Access Compliance Report

Public Rights-of-Way

Intersection ID: 27363	Main Street: REA_RD	Cross Street: BALLANTYNE_COMMONS_PY	Location: NW
ADA ID: C582484330C2	Ramp Type: Perp	Initial Pass/Fail: Fail	Overall Compliance: No
Severity Score: 13.75			
Codes/Mitigation Info/Possible Solution		Field Measurements/Component Compliance

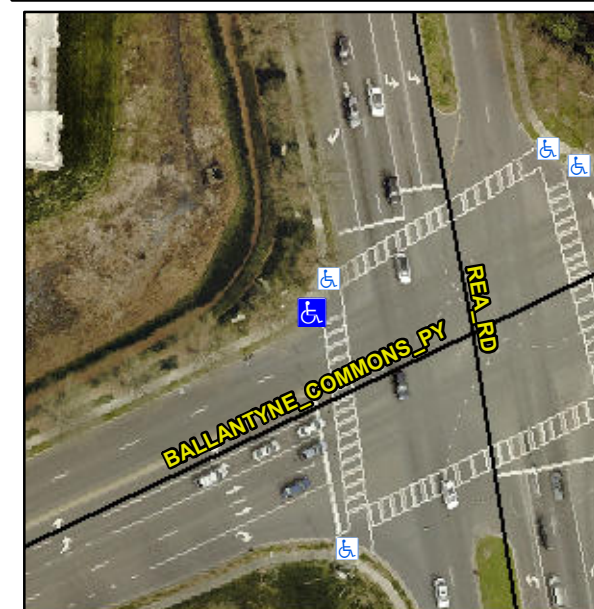
Not Found, R304.2.2, R304.5.3

Compliance	Description	Data	Compliance	Description	Data
N/A	Ramp Length (in)	107.0	No	Ramp Slope (%)	11.1
Yes	Ramp Width (in)	51.0	No	Ramp XSlope (%)	3.6
N/A	Flare Type LT	N/A	N/A	Flare Type RT	N/A
N/A	Flare Slope LT (%)	N/A	N/A	Flare Slope RT (%)	N/A
N/A	Flare Traversable LT?	N/A	N/A	Flare Traversable RT?	N/A
N/A	Landing Length (in)	N/A	N/A	DWS Provided?	N/A
N/A	Landing Width (in)	N/A	N/A	DWS Contrast?	N/A
N/A	Landing Slope (%)	N/A	N/A	DWS Length (in)	N/A
N/A	Landing X Slope (%)	N/A	N/A	DWS Full Width?	N/A
N/A	Landing Curb? (Y/N)	N/A	N/A	DWS Offset (in)	N/A
N/A	Shared Landing?	N/A			
N/A	Gutter Ponding?	N/A	N/A	Gutter Slope (%)	N/A
N/A	Gutter Lip Ht (in)	N/A	N/A	Gutter X Slope (%)	N/A
N/A	Painted X Walk1?	Yes	N/A	Painted X Walk2?	N/A
	X Walk 1 Direction	To S		X Walk 2 Direction	N/A
N/A	X Walk 1 Width (in)	126.0	N/A	X Walk 2 Width (in)	N/A
	X Walk 1 Slope (%)	3.1		X Walk 2 Slope (%)	N/A
	X Walk 1 X Slope (%)	0.9		X Walk 2 X Slope (%)	N/A

**Remove & Replace Entire Ramp.
Restripe Crosswalk.**
